ADDENDUM NUMBER 1

DATE: 05/12/2025

PROJECT: City Hall Restroom Renovation

PROJECT NUMBER: 0100-0569

A412

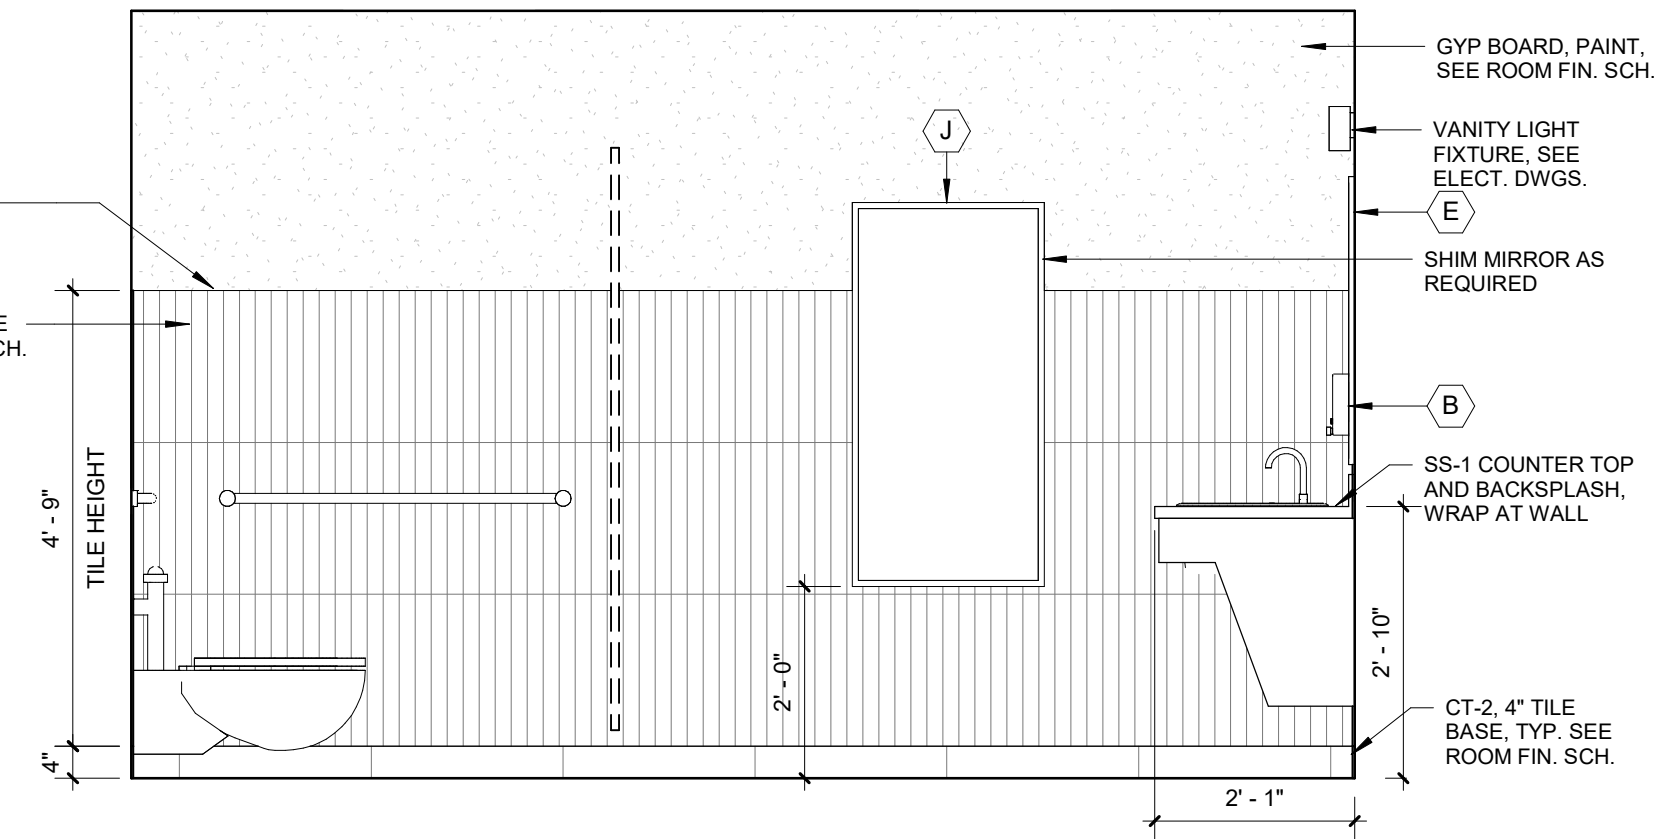
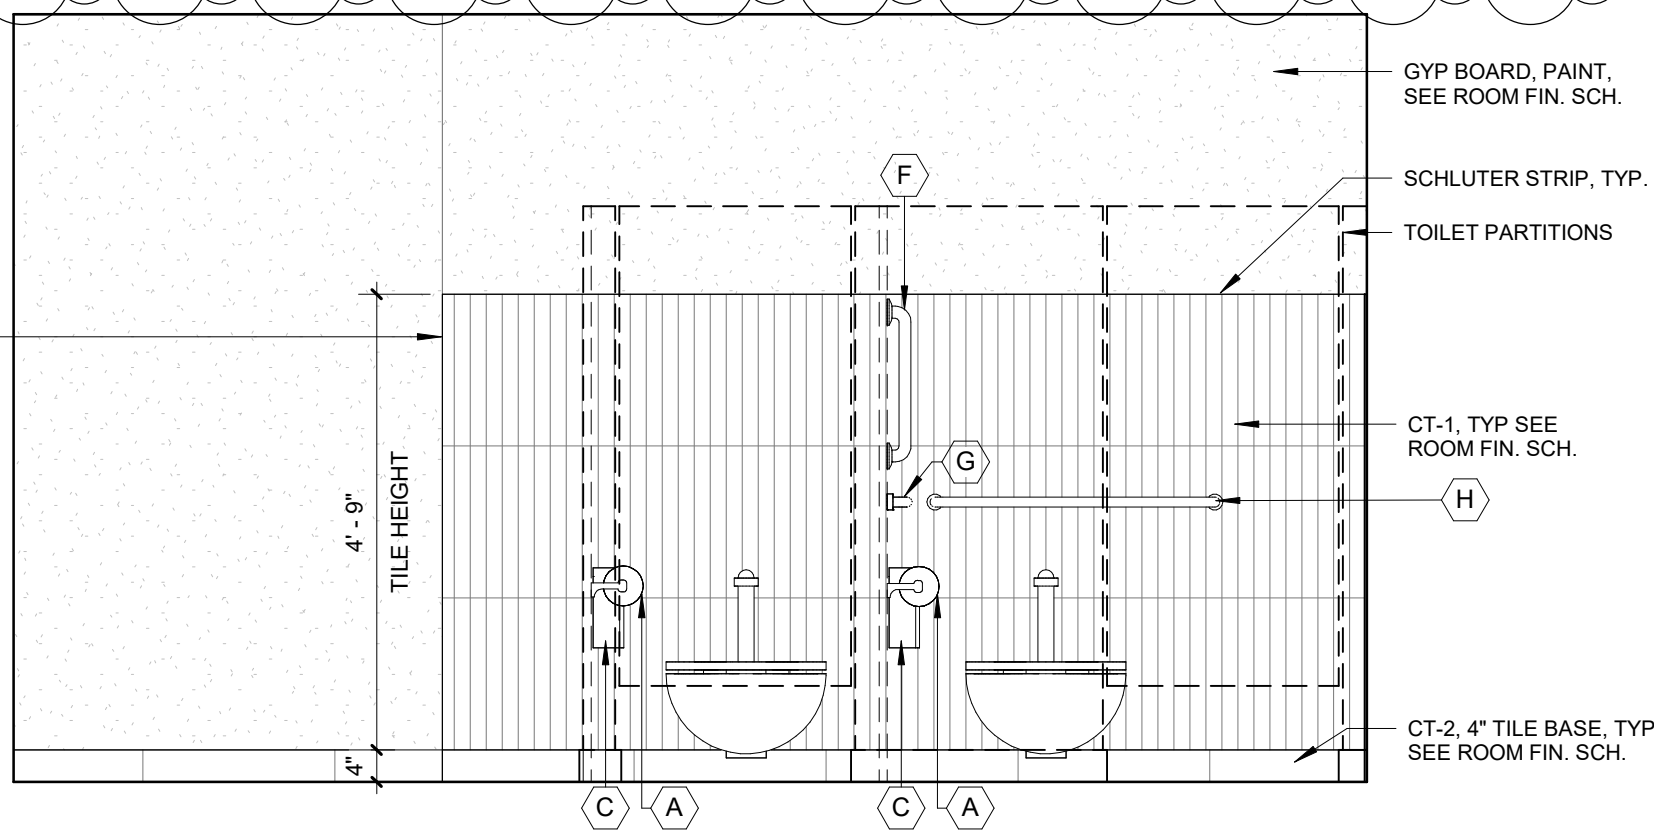
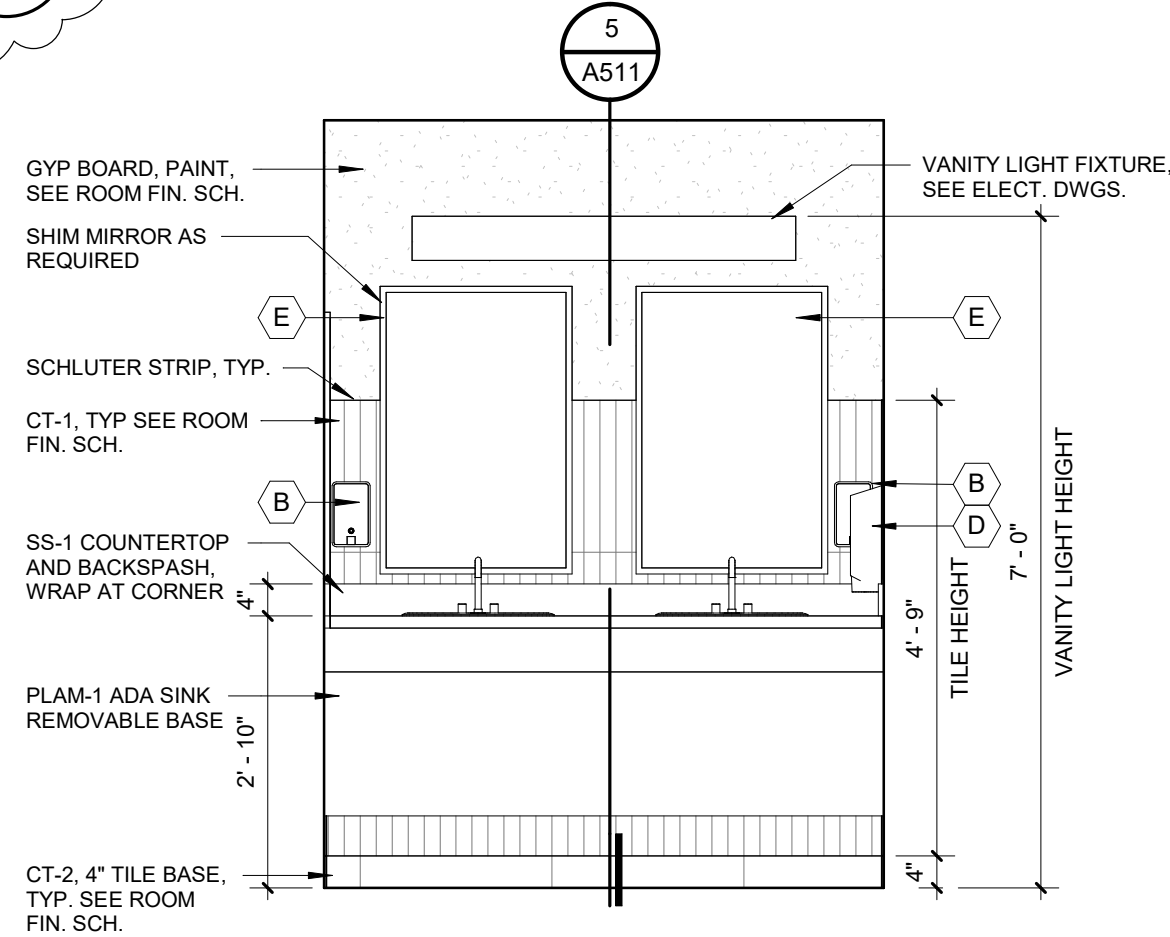
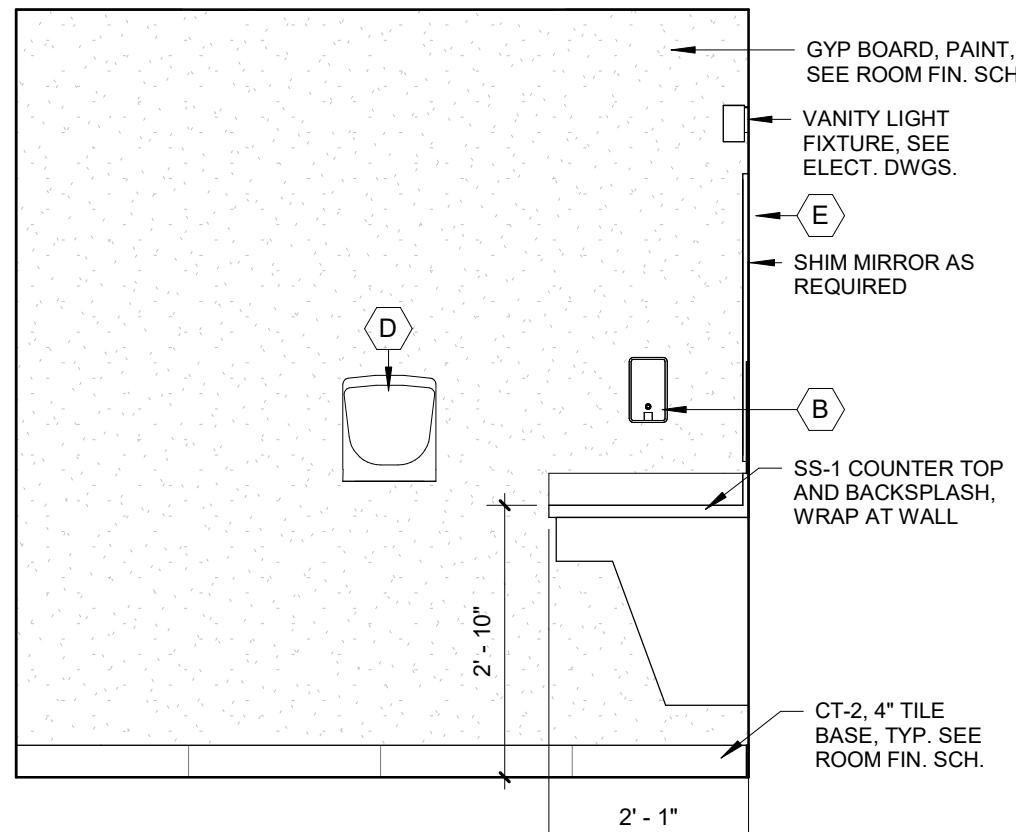
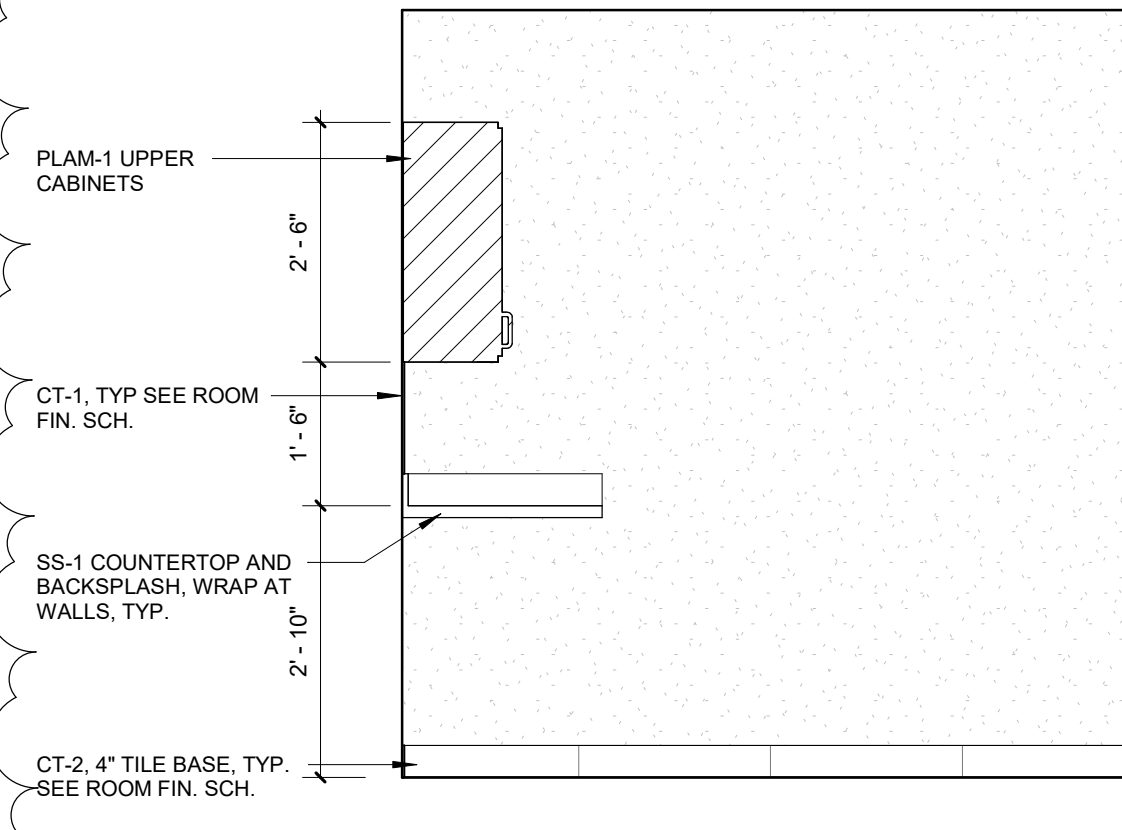
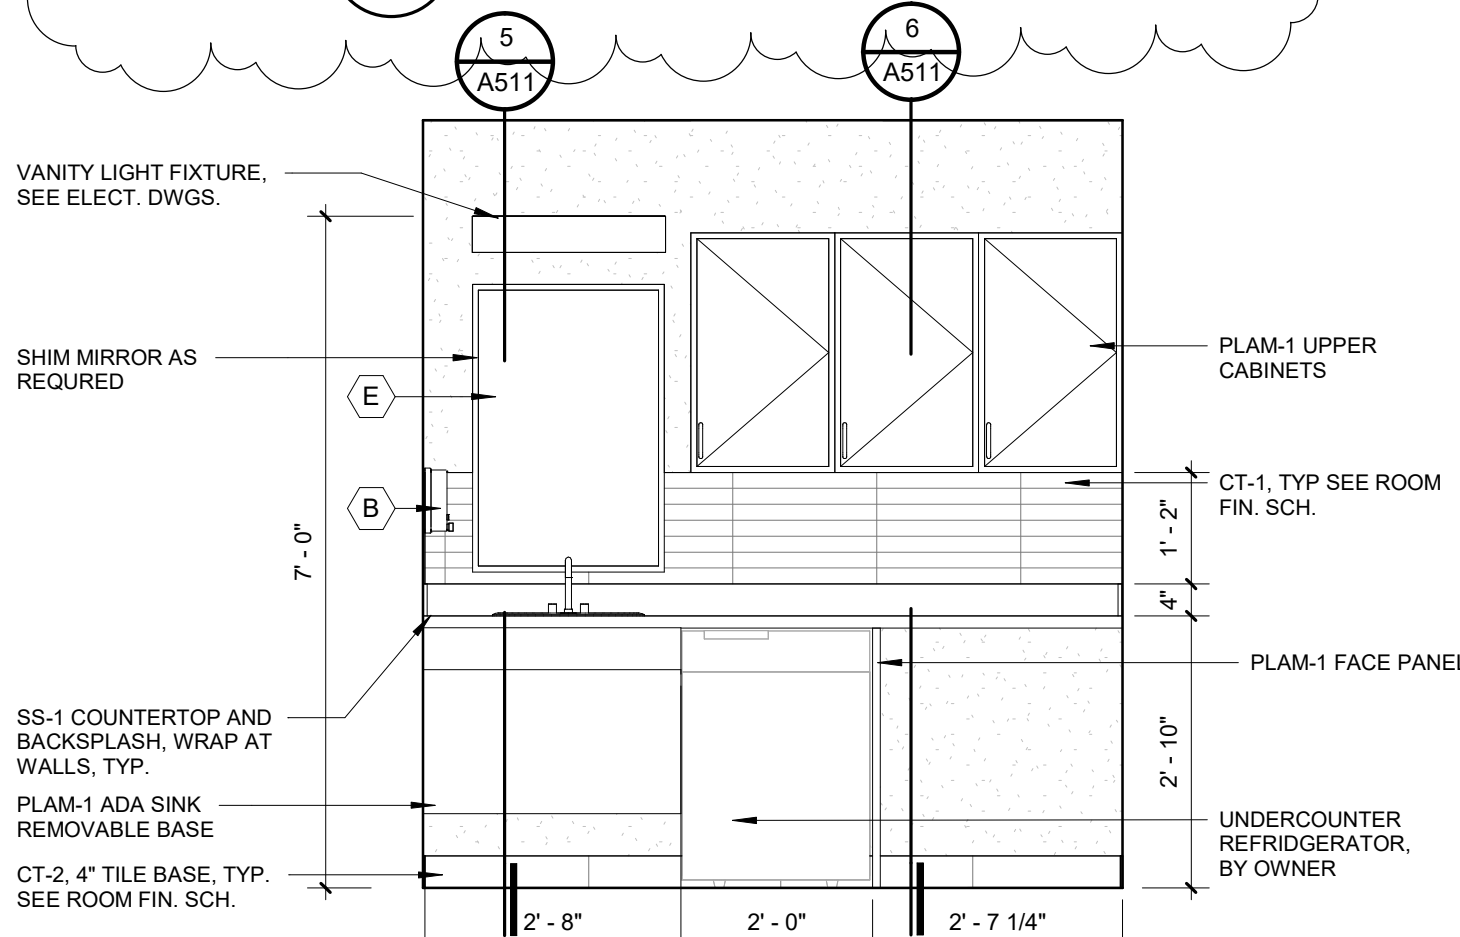
22. **Q:** Please clarify the mother's room sign style
A: Provide signage as described by specification on A031. Owner to provide final room name during shop drawing review.
23. **Q:** Please provide specifications and details for the bathroom signage
A: Refer to specifications on A031 and details on A611
24. **Q:** Please provide elevations for the following walls:
Restroom 101- West wall, Restroom 103 - North wall, Restroom 104 - East & West walls, Restroom 105 - North & South walls
A: See added elevations on A411 and A412

- c. 7/A411: Tile extended
 - d. 1/A411: Tile extended
7. SHEET A412: issued
 - a. New sheet
 - b. Added 3/A412, 4/A412, 6/A412, 7/A412 interior elevations

- c. 9/A412: Tile extended between vanity and door
8. Sheet A611: reissued
